UNITED STATES PATENT AND TRADEMARK OFFICE

10/662,216

Office Action Summary	Application No. 10/662,216	Applicant(s) PAVCNIK ET AL.	
	Examiner AMY T. LANG	Art Unit 3731

DETAILED ACTION

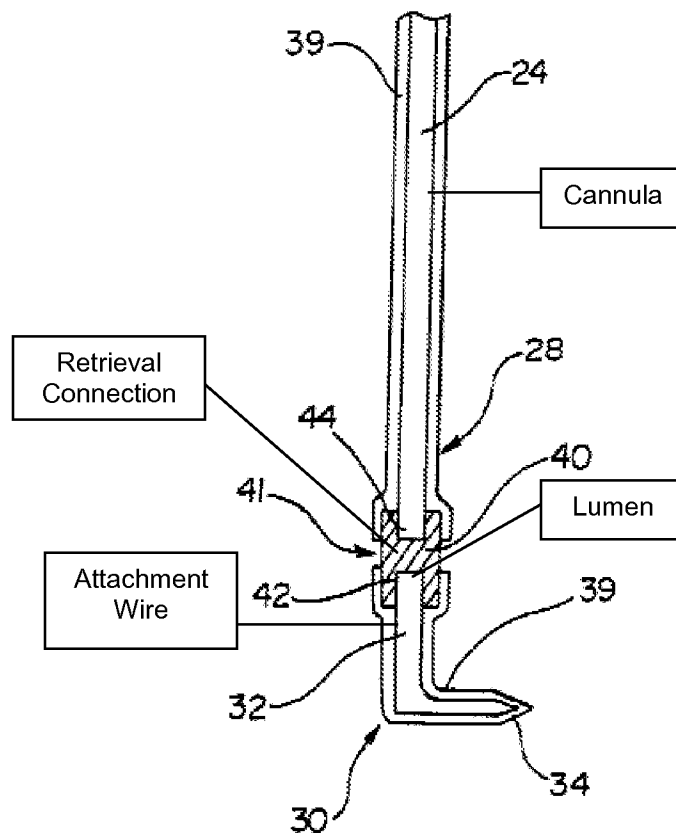
Yassour discloses a filter attached to a stent through a first and second attachment means but fails to disclose one of the attachment means as extending through a lumen in the filter legs.

DeVries et al. (hereinafter DeVries) discloses a retrievable filter comprising a first end connected to a second end through an attachment member that advantageously secures the two ends while allowing the two ends to become separated (Figure 3). As

shown in Figure 3 and below, each filter leg (24) comprises a cannula (24) having a distal lumen. Attachment wire (32) is disposed within the filter lumen and is attached at a retrieval connection point (41). Since DeVries teaches an advantageous attachment mechanism that is well known in the art, it would have been obvious at the time of the invention to one of ordinary skill in the art for the retrievable filter of Yassour to utilize the same attachment means.

If Applicant were to argue that member (32) of Devries is not an attachment wire, it is the examiner's position that member (32) is a slender filament and therefore overlaps a wire.
